# IRON HAMMER - SITE PLAN AMENDMENT

A PORTION OF LOTS 1 & 2, BLOCK 1, AURORA CENTRETECH PARK SUBDIVISION FILING NO. 8, LOCATED IN THE NORTHWEST QUARTER OF SECTION 8, TOWNSHIP 4 SOUTH, RANGE 66 WEST OF THE 6TH P.M., CITY OF AURORA, COUNTY OF ARAPAHOE, STATE OF COLORADO

PROJECT #	IH2215
PROJECT DATE	04/28/2023
DESIGNER	SAK
REVIEWER	JSD

**OVERALL GRADING PLAN**

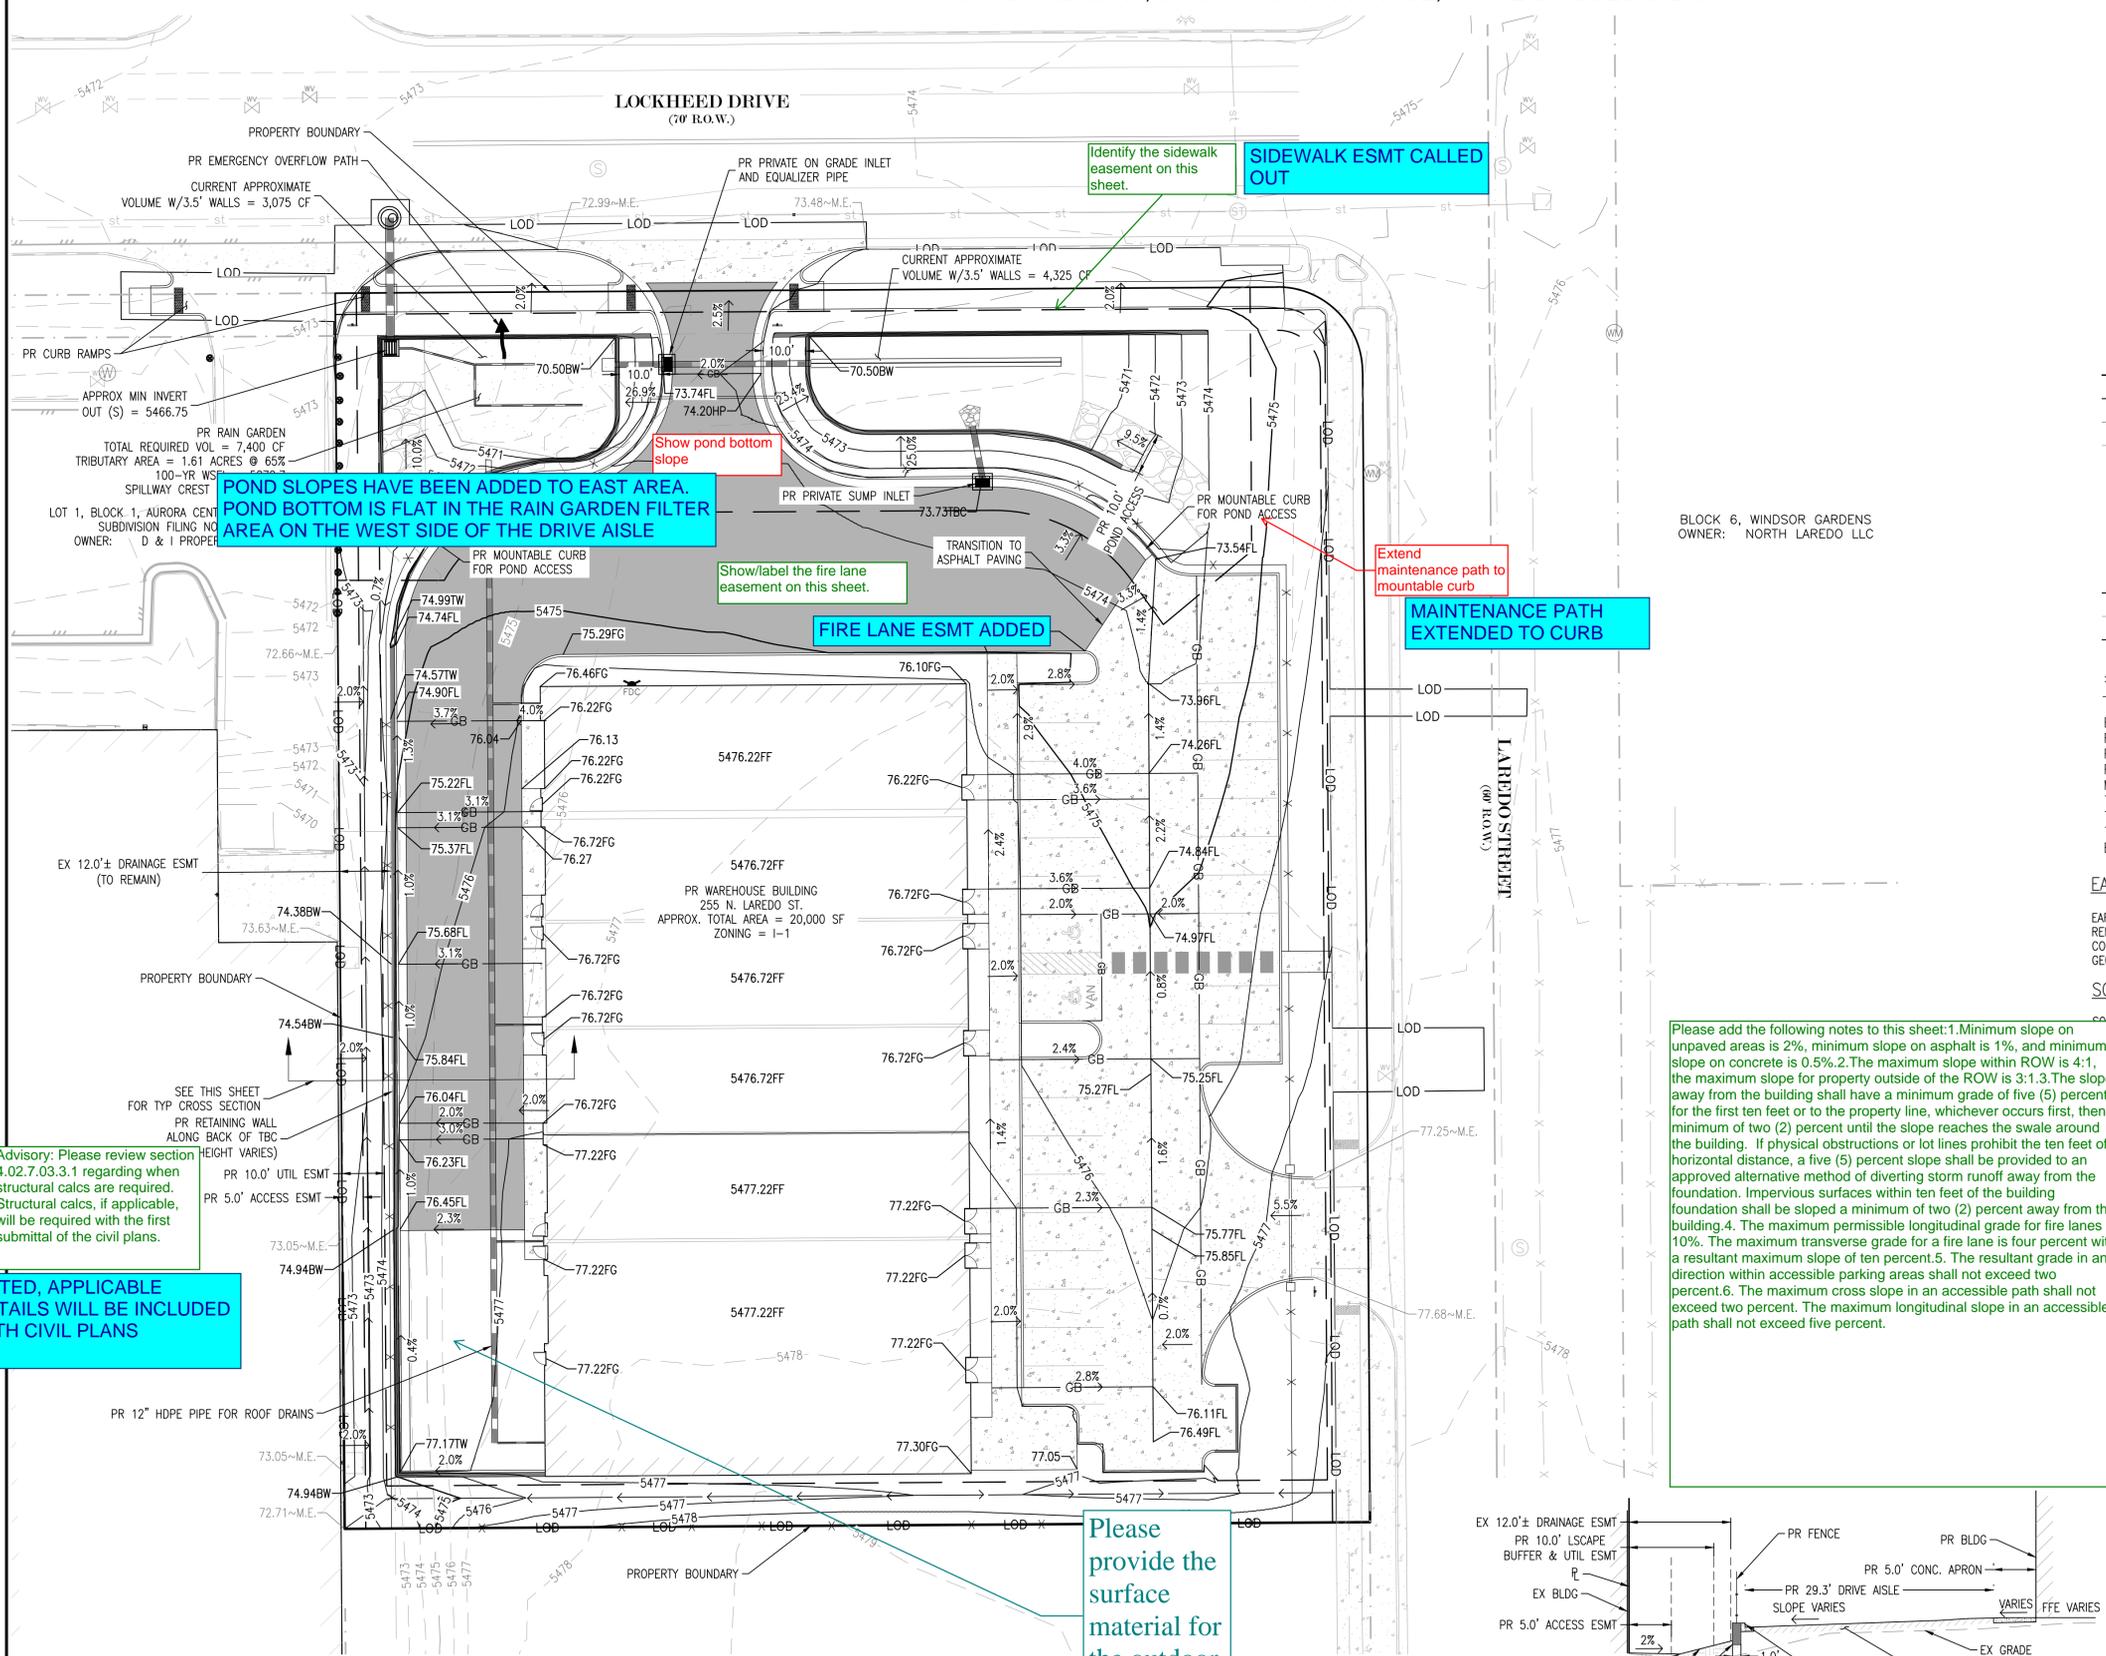
Please add the following notes to this sheet: 1. Minimum slope on unpaved areas is 2%, minimum slope on asphalt is 1%, and minimum slope on concrete is 0.5%. 2. The maximum slope within ROW is 4:1, the maximum slope for property outside of the ROW is 3:1. 3. The slope away from the building shall have a minimum grade of five (5) percent for the first ten feet or to the property line, whichever occurs first, then a minimum of two (2) percent until the slope reaches the swale around the building. If physical obstructions or lot lines prohibit the ten feet of horizontal distance, a five (5) percent slope shall be provided to an approved alternative method of diverting storm runoff away from the foundation. Impervious surfaces within ten feet of the building foundation shall be sloped a minimum of two (2) percent away from the building. 4. The maximum permissible longitudinal grade for fire lanes is 10%. The maximum transverse grade for a fire lane is four percent with a resultant maximum slope of ten percent. 5. The resultant grade in any direction within accessible parking areas shall not exceed two percent. 6. The maximum cross slope in an accessible path shall not exceed two percent. The maximum longitudinal slope in an accessible path shall not exceed five percent.

Advisory: Please review section 4.02.7.03.3.1 regarding when structural calcs are required. Structural calcs, if applicable, will be required with the first submittal of the civil plans.

Please provide the surface material for the outdoor storage area

Show pond bottom slope

Show/label the fire lane easement on this sheet.

Extend maintenance path to mountable curb

Identify the sidewalk easement on this sheet.

**NOTE ADDED**

**NOTED, APPLICABLE DETAILS WILL BE INCLUDED WITH CIVIL PLANS**

**THIS AREA IS TO BE PAVED. HATCH REVISED**

**SIDEWALK ESMT CALLED OUT**

**MAINTENANCE PATH EXTENDED TO CURB**

**FIRE LANE ESMT ADDED**

**POND SLOPES HAVE BEEN ADDED TO EAST AREA. POND BOTTOM IS FLAT IN THE RAIN GARDEN FILTER AREA ON THE WEST SIDE OF THE DRIVE AISLE**

**OVERALL UTILITY PLAN**

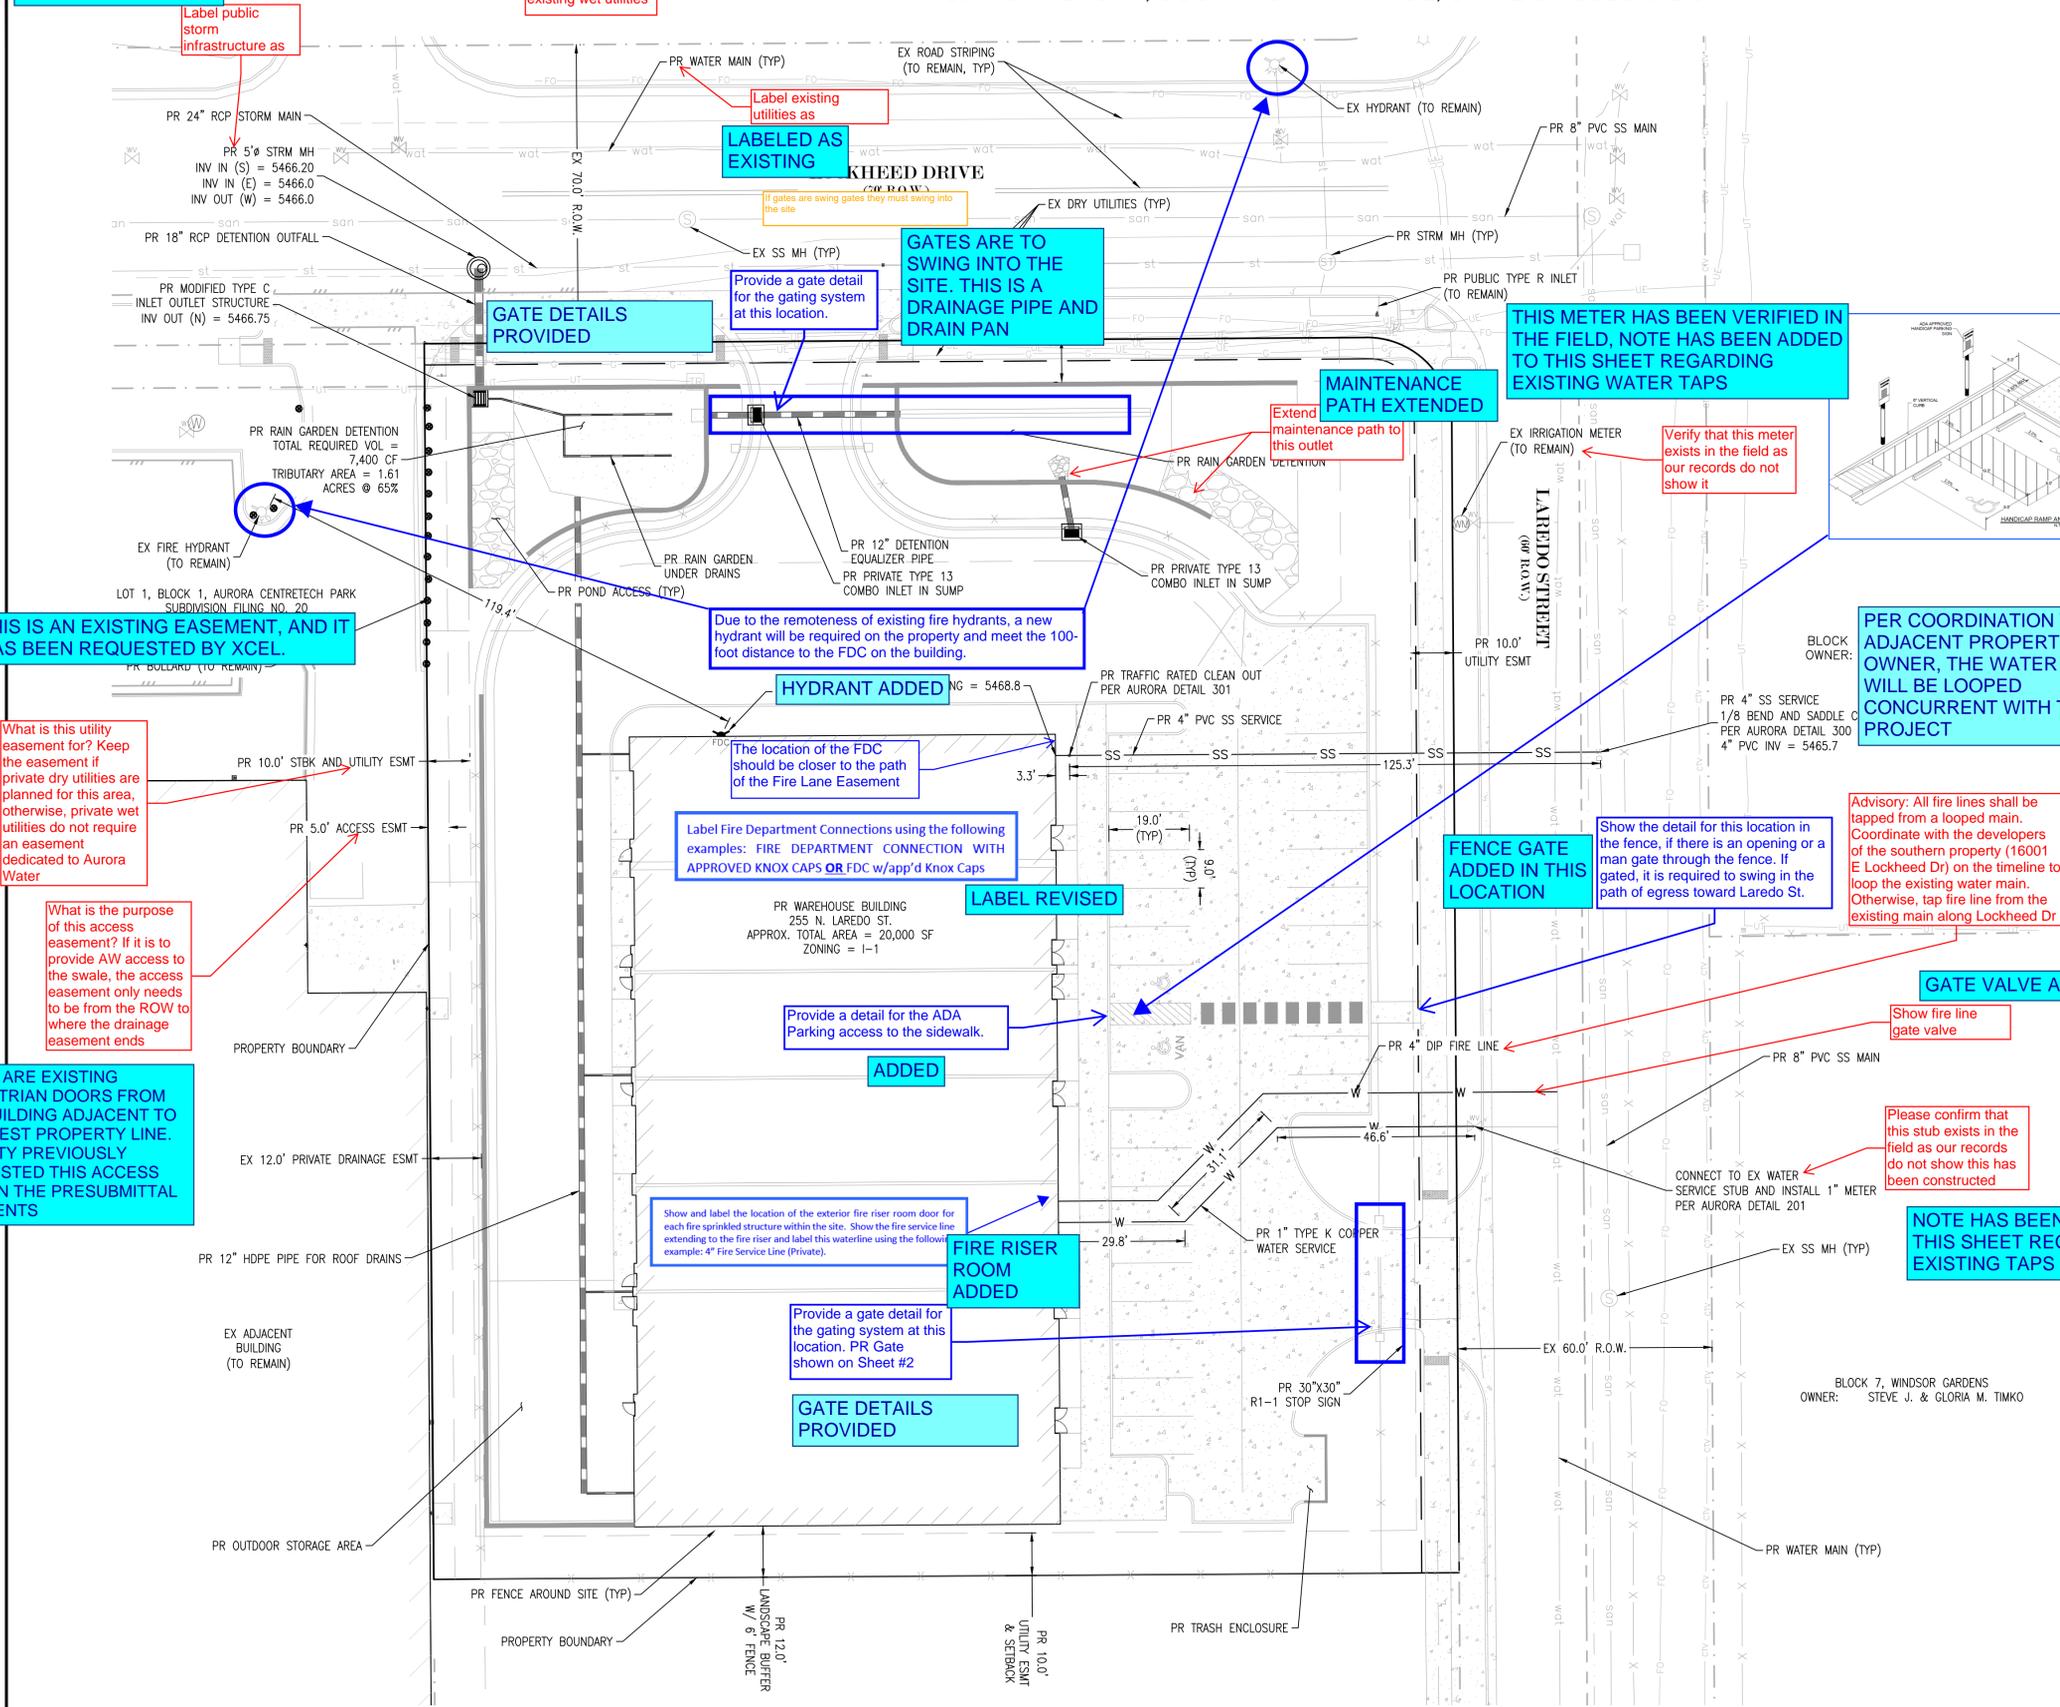
Show pipe diameters of all existing wet utilities

Due to the remoteness of existing fire hydrants, a new hydrant will be required on the property and meet the 100-foot distance to the FDC on the building.

The location of the FDC should be closer to the path of the Fire Lane Easement

Label Fire Department Connections using the following examples: FIRE DEPARTMENT CONNECTION WITH APPROVED KNOX CAPS OR FDC w/app'd Knox Caps

Provide a detail for the ADA Parking access to the sidewalk.

Provide a gate detail for the gating system at this location. PR Gate shown on Sheet #2

Advisory: All fire lines shall be tapped from a looped main. Coordinate with the developers of the southern property (16001 E Lockheed Dr) on the timeline to loop the existing water main. Otherwise, tap fire line from the existing main along Lockheed Dr

Show fire line gate valve

Please confirm that this stub exists in the field as our records do not show this has been constructed

Provide these notes: 1) Water service lines are public up through the meter and are private downstream of the meter. 2) All sanitary service connections are private. 3) All storm is private unless otherwise noted and shall be maintained by the property owner.

**DIAMETERS OF WET UTILITIES HAVE BEEN ADDED**

**"PR" IS PROPOSED IN THIS PLAN SET**

**LABELED AS EXISTING**

**GATES ARE TO SWING INTO THE SITE. THIS IS A DRAINAGE PIPE AND DRAIN PAN**

**GATE DETAILS PROVIDED**

**MAINTENANCE PATH EXTENDED**

**THIS METER HAS BEEN VERIFIED IN THE FIELD. NOTE HAS BEEN ADDED TO THIS SHEET REGARDING EXISTING WATER TAPS**

**THIS IS AN EXISTING EASEMENT, AND IT HAS BEEN REQUESTED BY XCEL.**

**HYDRANT ADDED**

**LABEL REVISED**

**ADDED**

**FIRE RISER ROOM ADDED**

**GATE DETAILS PROVIDED**

**PER COORDINATION WITH ADJACENT PROPERTY OWNER, THE WATER MAIN WILL BE LOOPED CONCURRENT WITH THEIR PROJECT**

**GATE VALVE ADDED**

**NOTE HAS BEEN ADDED TO THIS SHEET REGARDING EXISTING TAPS**

**NOTES ADDED**
